## Modifications to Coastal Grove Residential Subdivision (MP06\_0002) 1 Survey Street Lennox Head

### SECTION 75W APPLICATION

Submitted to: NSW Department of Planning

Date: May 2009

**Figure 1: Recommended cycleway/footpath and sewer route through HJG polygon.**

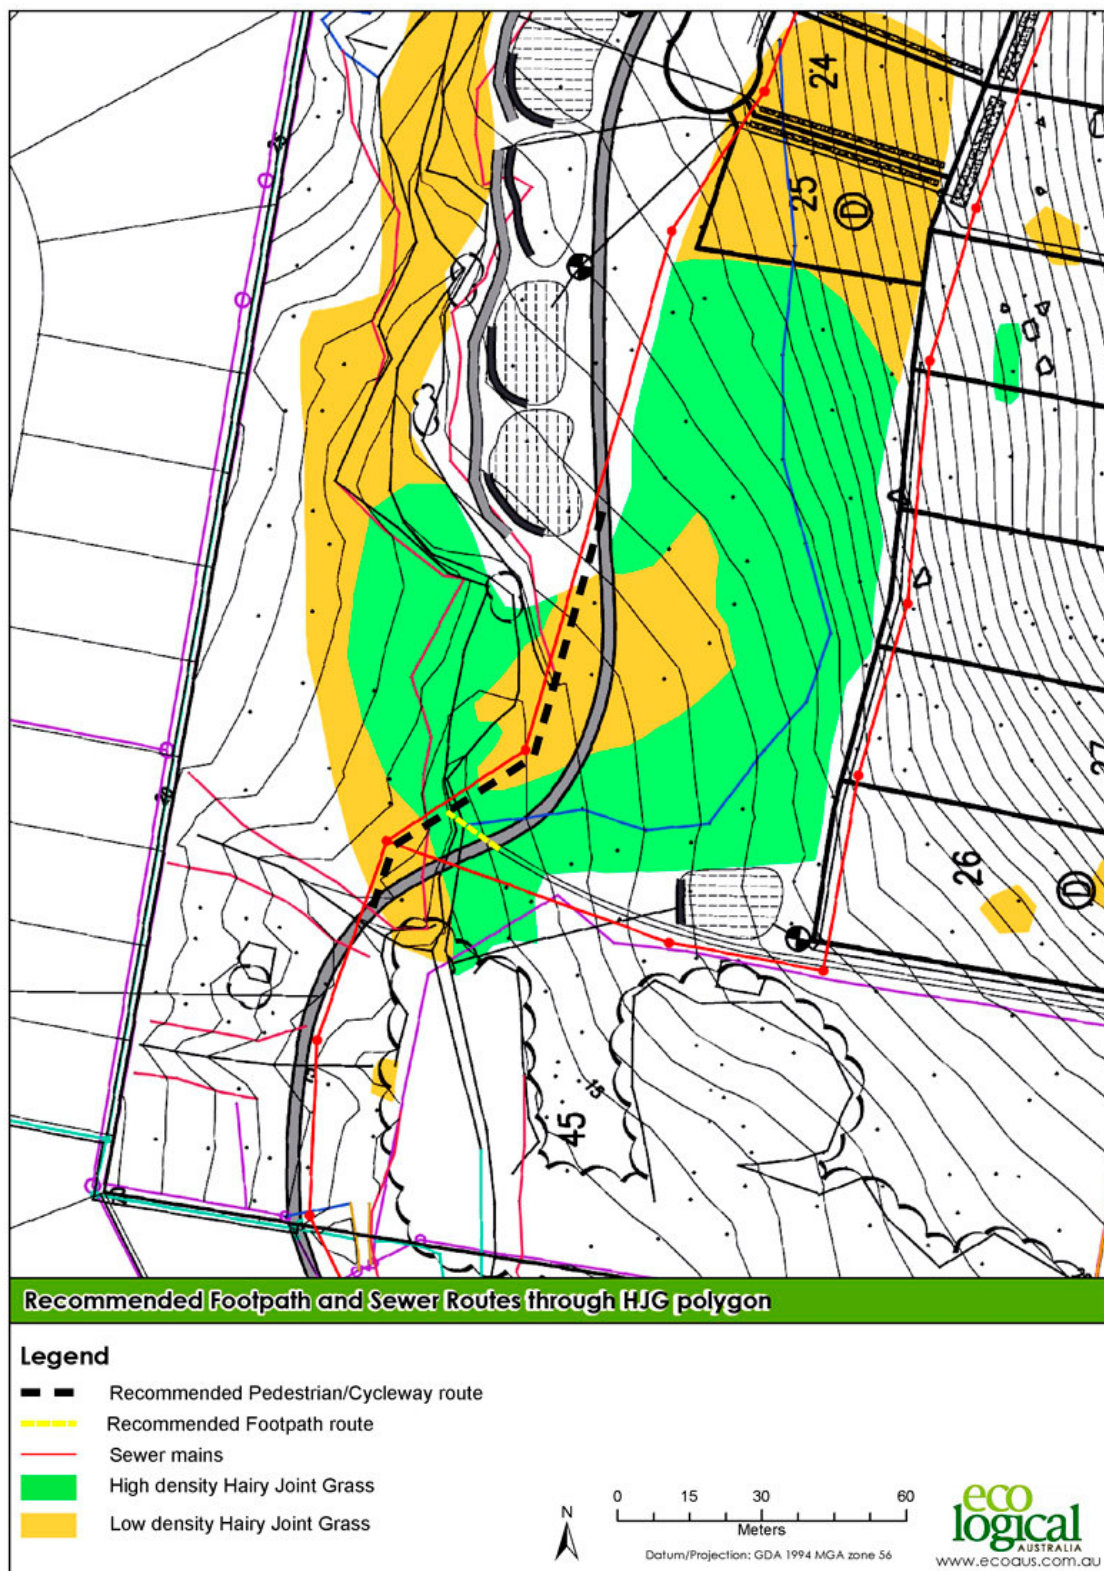
Note that the recommended route passes through a high density patch of HJG in the main drainage line. This is unavoidable due to the gravity-related constraints of the sewer main. However, the construction of an elevated, light-porous structure across this area is considered to be the best method of retaining HJG habitat, as ambient light levels and the current site hydrology would not be affected by the paths. In order to enable management of the HJG through seasonal slashing and weed control (as required in the site EMP), the elevated walkway/cycleway would need to be high enough to allow access to the entire ground area covered by the walkway.

1. The sewer and cycleway/footpath shall follow the same route through the HJG polygon.
2. All sewer and footpath/cycleway construction works to be undertaken during winter. This will minimise impact upon HJG, as mature plants die back over the winter months, and HJG seedlings do not emerge until spring (Ecos Environmental 2004). The winter months are also the driest months of the year, therefore reducing the risk of heavy rain disrupting works, creating soil erosion issues and potentially depositing weed seeds into disturbed areas.

6. An elevated walkway/cycleway to be constructed over the high density area of HJG in the main drainage line. The elevated platform shall be sufficiently high enough, and perforated, to enable enough light to penetrate to the ground beneath it to ensure persistence of HJG.
